**Reference:** Case No. PD-270-RBN, The Avenue at Denton Tap, a zoning change request from Commercial to a Planned Development to allow 29 multifamily units and 8,575 square feet of office/retail uses on 1.77 acres of property located at the northwest corner of Southwestern Boulevard and South Denton Tap Road.

**CASE NO. PD-270-RBN, The Avenue at Denton Tap**

**REQUEST:**             A zoning change to PD-270-RBN (Planned Development-270-Residential Urban Neighborhood), to allow 29 multifamily units and 8,575 square feet of office/retail uses.

# Mock City Council Meeting March 21, 2018

Site Plan

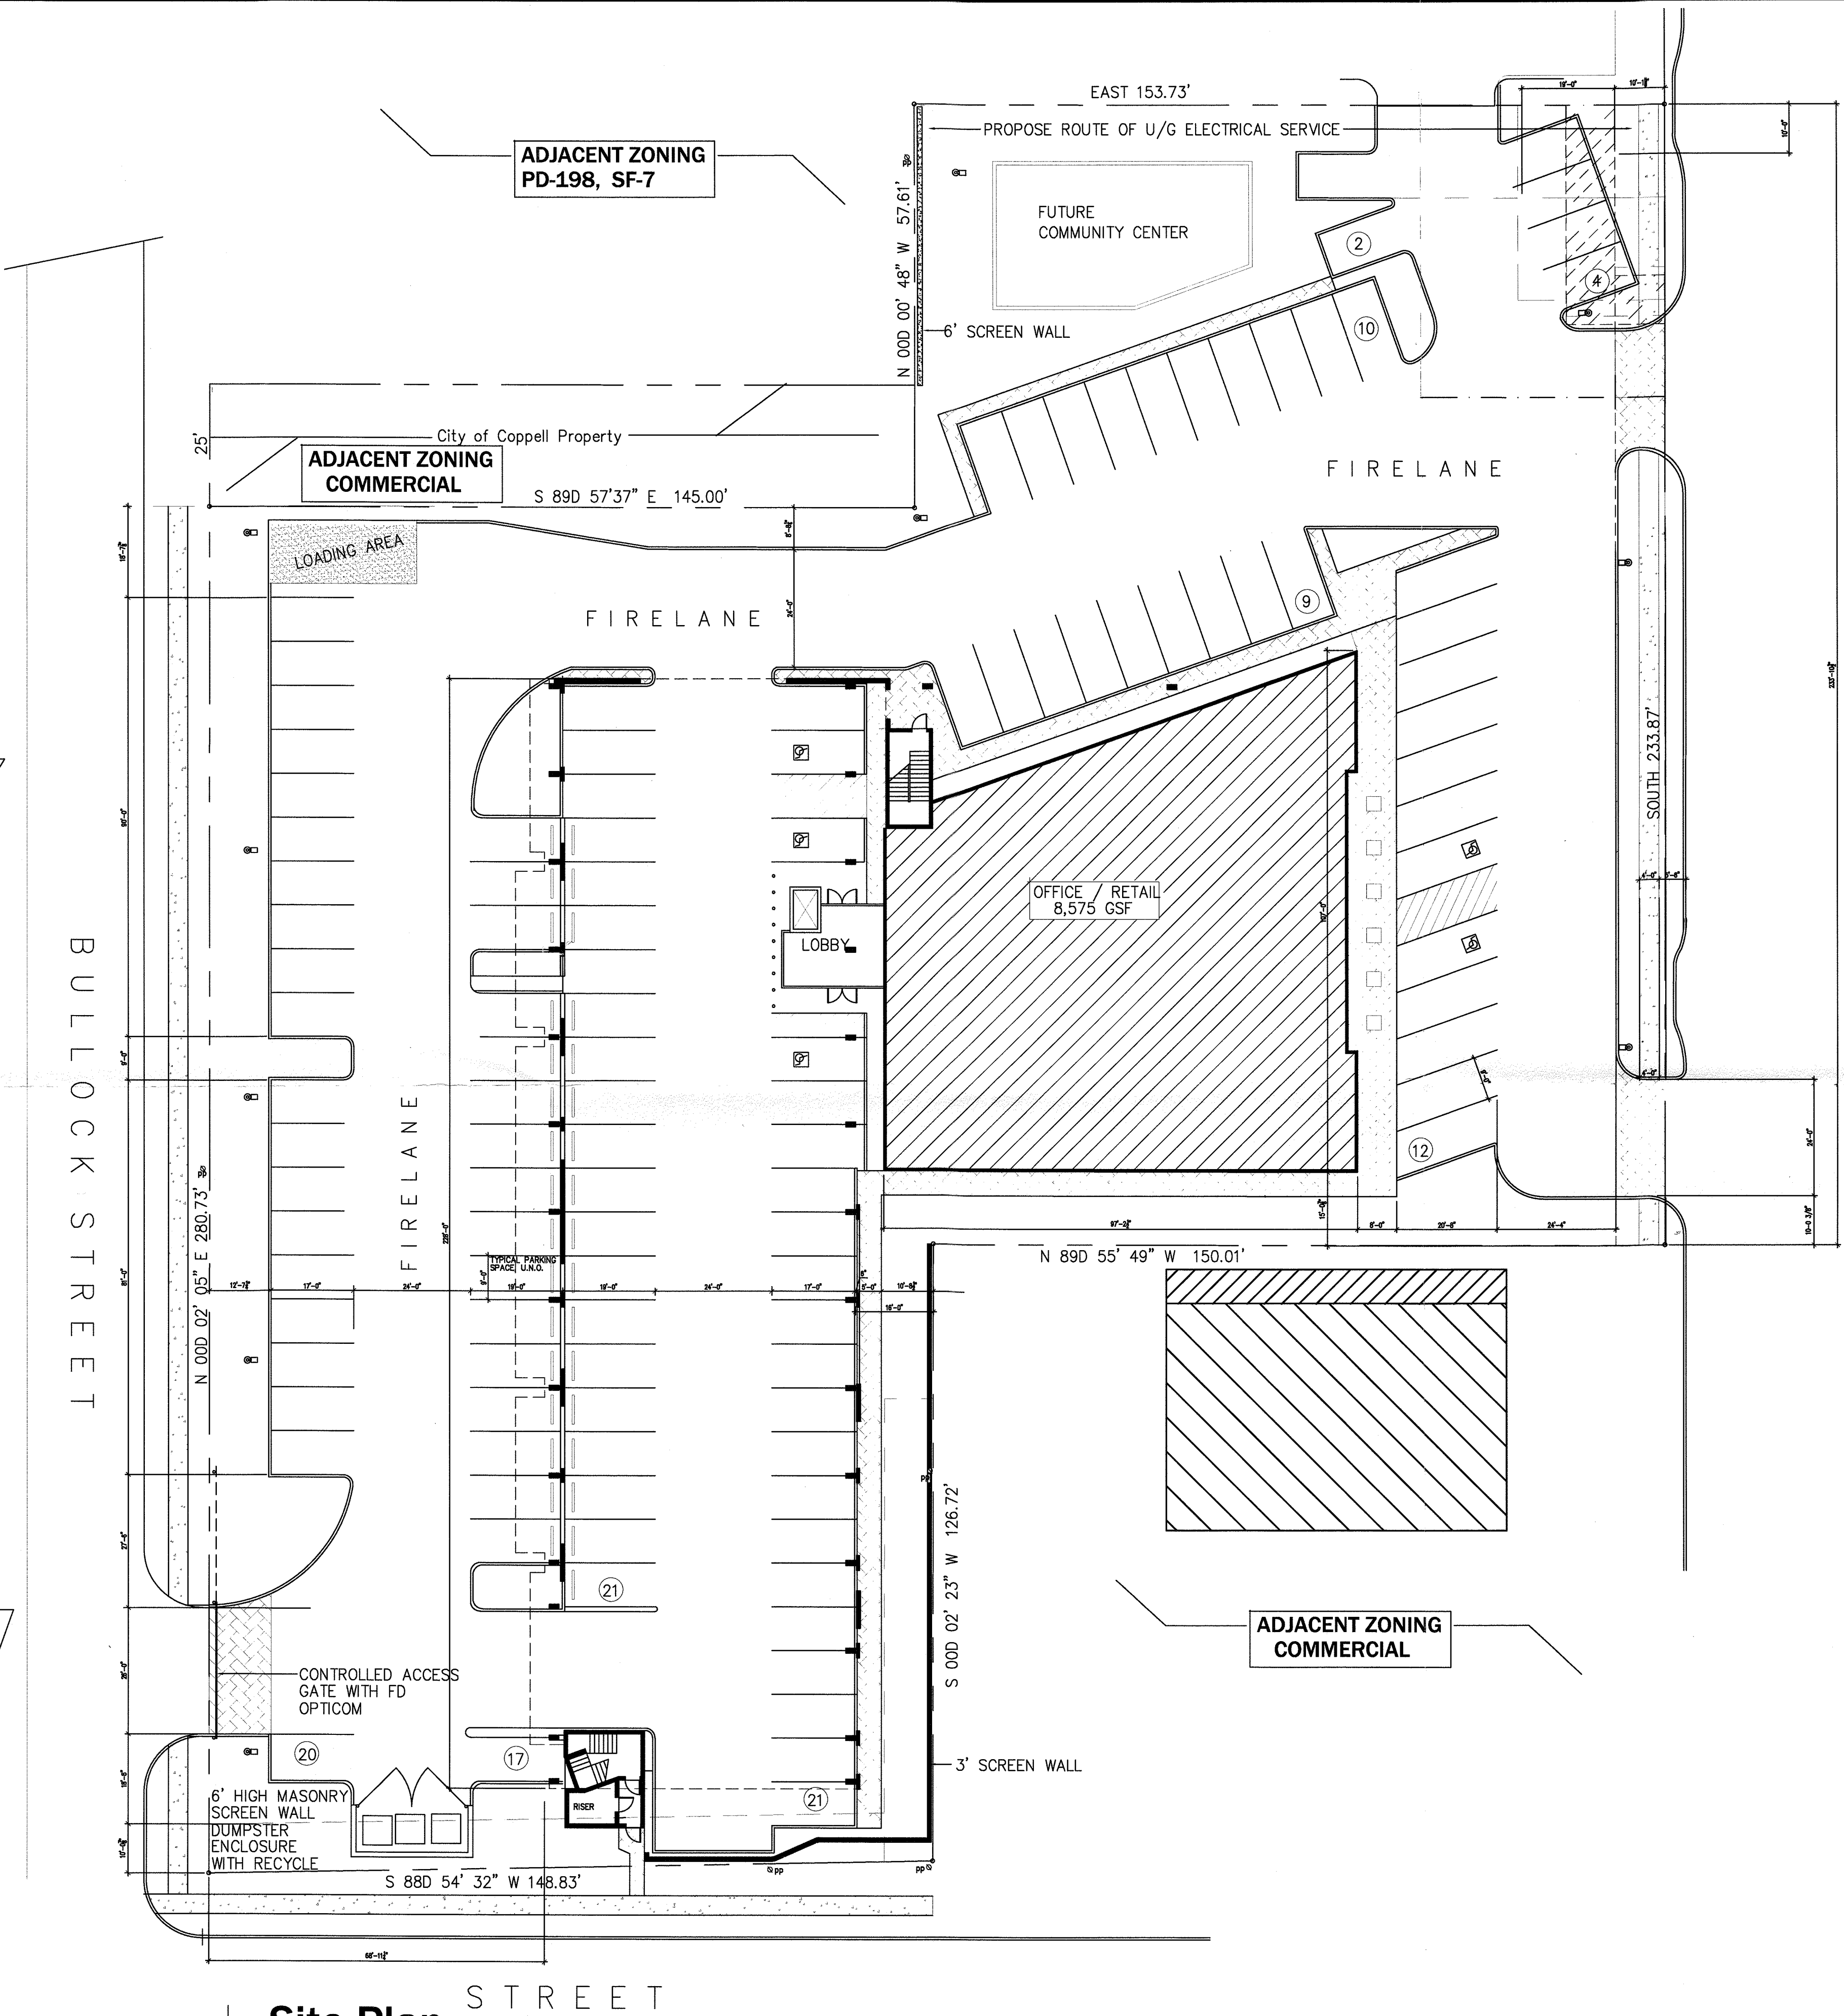
This building is proposed to be setback 63 feet from Denton Tap Road and 69 feet from Bullock Street. It is recommended that the 69-foot setback be supported to keep a buffer and transition from the residential neighborhood into the proposed higher intensity mixed use development.

A 36-foot setback is proposed along the northwest property line, which is adjacent to a 25-foot right-of-way providing a greater separation from the residential neighborhood. The main building is 63 feet from the Denton Tap Road right-of-way where the RBN District calls for a building to be no more than 15 feet from the lot line. Staff can support this deviation, as both a drive and parking are warranted for the office/retail use.

This proposal exceeds the 116 parking space requirement by providing 119 spaces. Both the *Comprehensive Plan* and the RBN District encourages structured (garage) parking. In this development 41 of the 119 spaces are contained within the structure. It is recommended that this parking area on the first floor be better screened with a three-foot masonry wall incorporated into each façade and this has

been listed as a condition of approval. Beyond the structured parking are 41 spaces in a parking lot. This area is proposed to be screened with a 12 foot wide landscaped area east of Bullock Street. The proposed off-street parking and drive (similar to a slip street recognized in the Comprehensive Plan). The proposed parking located on the Denton Tap Road side is angled with a one-way drive to provide an opportunity for streetscaping without actually having dangerous on-street parking on Denton Tap.

| 5.  | A three-foot masonry wall shall be incorporated in the façades of the main building to better screen parking area contained within the building.   |
| 16. | Include a gate with controlled access (include opticom for Fire Department) at the southwest access point off of Bullock.  |
| 17. | Relocate the dumpster enclosure to the south end of the project.   |

1 LANDSCAPE PLAN

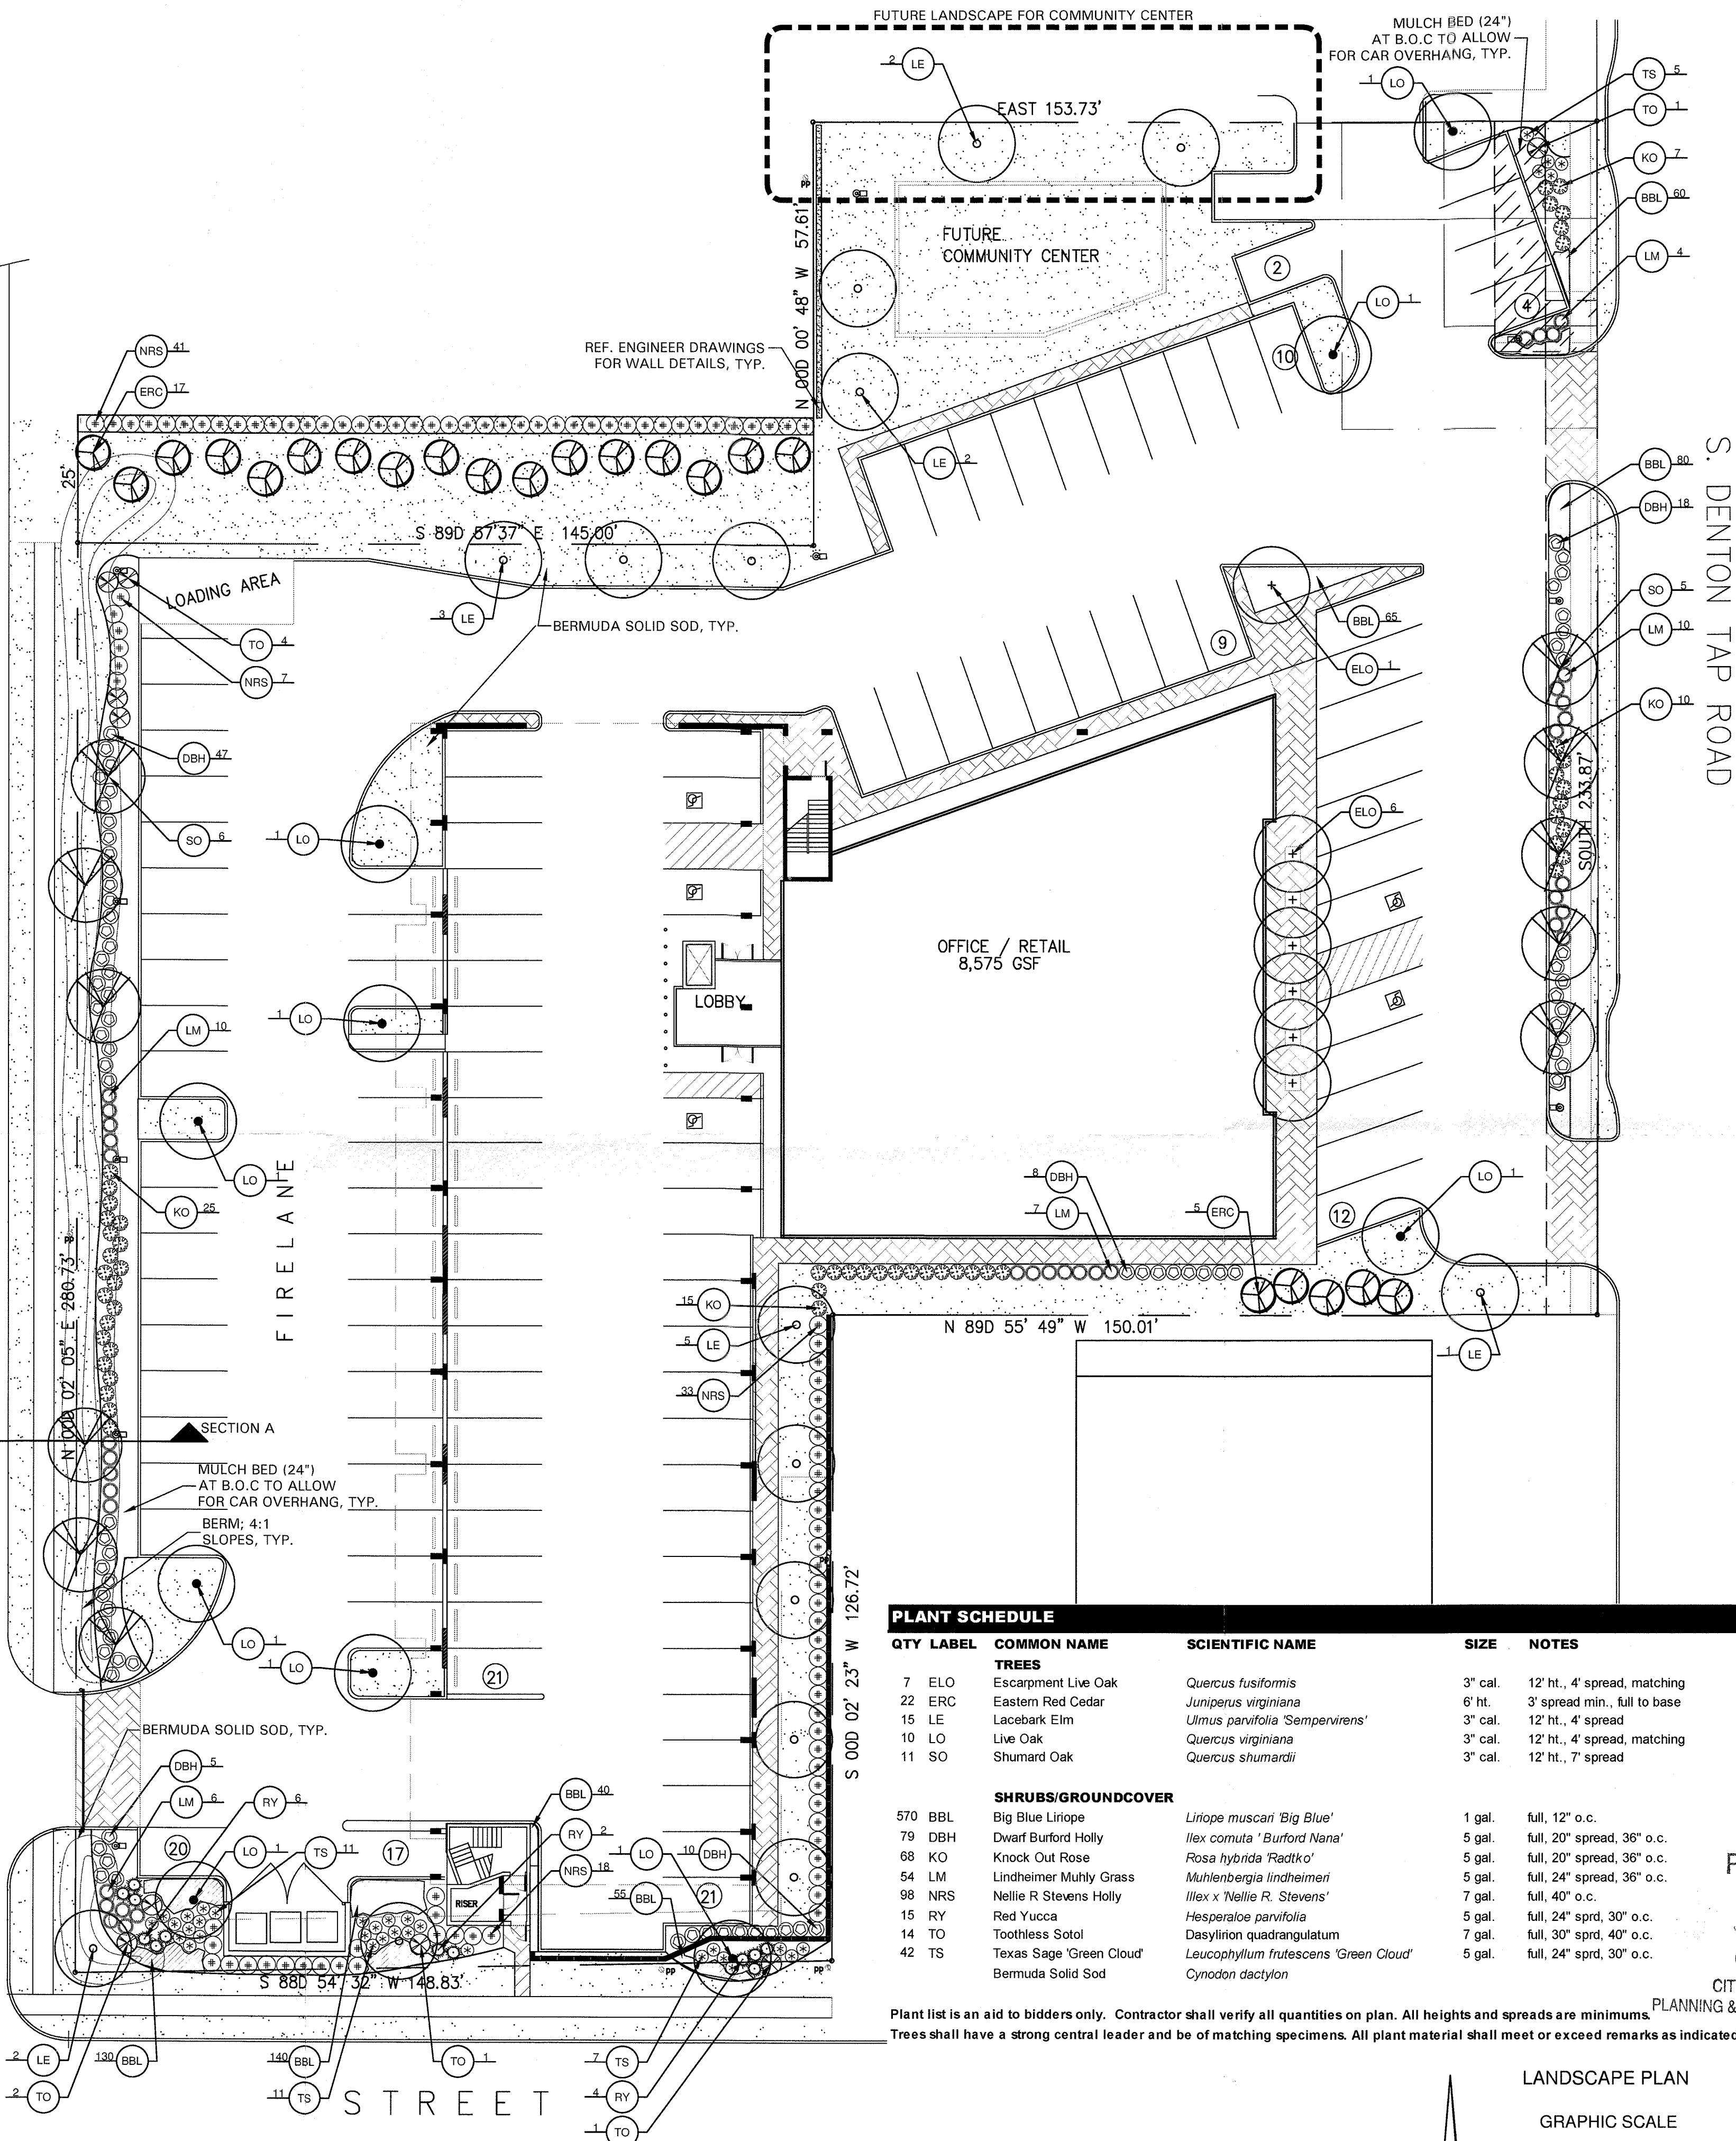
The landscape areas within a RBN District are different than the typical business zoning districts where under the RBN, a minimum 15% open space/common area is required. The proposal indicates that 17% has been provided. The streetscaping of the retail/office area is adequate where street trees are being provided. However, additional landscape islands are being recommended in the parking lot where there is no structure over the parking. Not more than 15 parking spaces are typically permitted without an island and one island is required at the end of each parking row; therefore, three islands are recommended. Also, the applicant has agreed to add an evergreen area of landscaping (containing Nellie R. Stevens and Eastern Red Cedars) to the 25 foot right-of-way strip located northwest of the property to better buffer/screen this proposal from the existing residential neighborhood.

| 8.  | Include three 150-square-foot landscape islands with an overstory tree within the proposed surface parking area where not under the structure. No more than 15 spaces are typically permitted without an island and one island is required at the end of each parking row. |
| 12. | Label the 25-foot right-of-way northwest of the site as City of Coppell Property. Include Eastern Red Cedars and Nellie R. Stevens south of the existing fence.  |
| 15. | Revise the Landscape Plan to include interim and future landscaping for the "Future Community Center" portion of the site.   |
